Late Correspondence
September 16, 2026 Planning Commission

On behalf of Adeline Alliance Partners, we respectfully ask the Planning Commission, at its September 16 hearing, to recommend that the City Council adopt the Objective Design Standards for the Ashby BART Station Transit-Oriented Development, with the three refinements described on the attached page. We support these standards and want them adopted on schedule. The changes we ask for are technical; none reopens the framework this community built.

Figure 7. Diagram of Access Drive Required Dimensions through Development Areas A and B (Illustrative Concept)

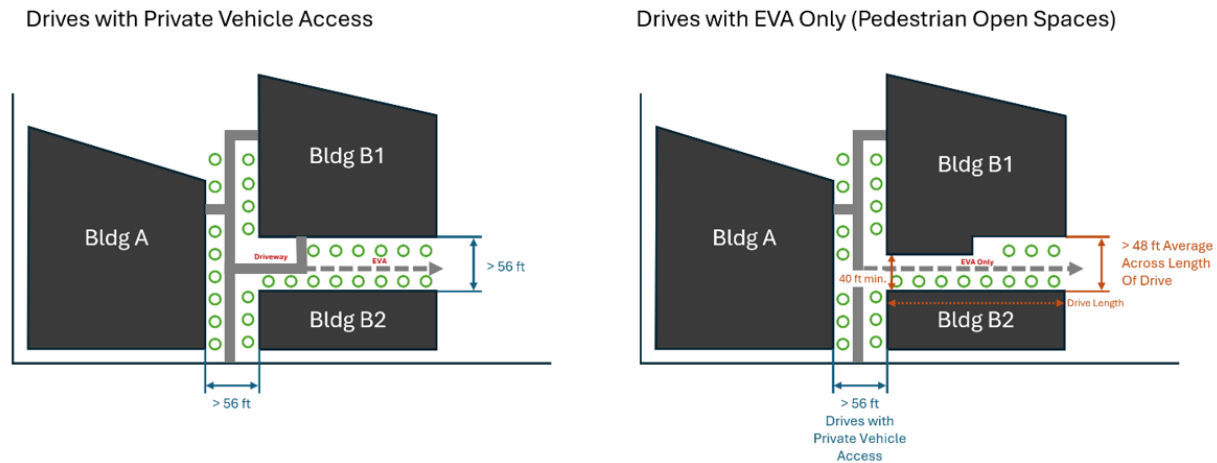
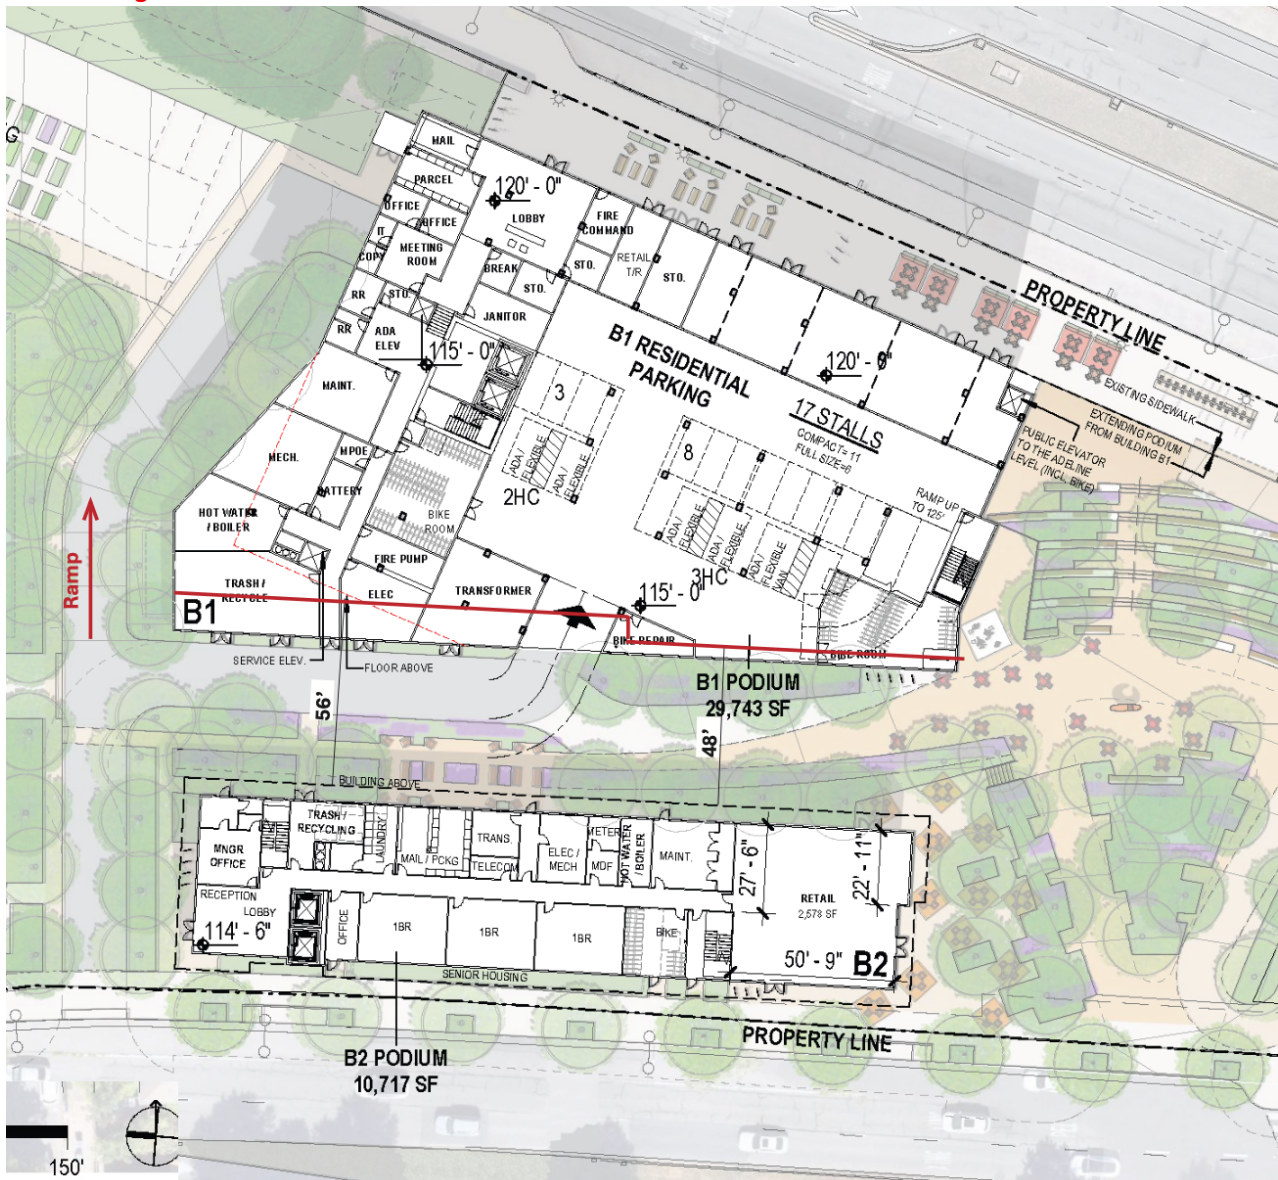
2.3.1 Access Drive Design. Set the minimum building-to-building width at 56 feet where a drive carries public vehicles and must support Fire Department ladder-truck access, and at a 45-foot average where a drive serves emergency access, private garage entries and residential service. One width cannot serve both functions. The 48-foot figure appears on pages 10, 28 and 52 and should be adjusted to match.

This revised language needs to be corrected in 3 locations which have the 48' requirement.

- a) Access drives (see Figure 7) a) Access drives with public vehicle access **and used for Fire Ladder Truck access** shall have a minimum building-to-building width of 60 56 feet. (see Figure 10)
- a) Access drives used **(eliminate solely)** for emergency vehicle access, **private garage access, and residential services** shall have a minimum average building-to-building width of **45'** feet.
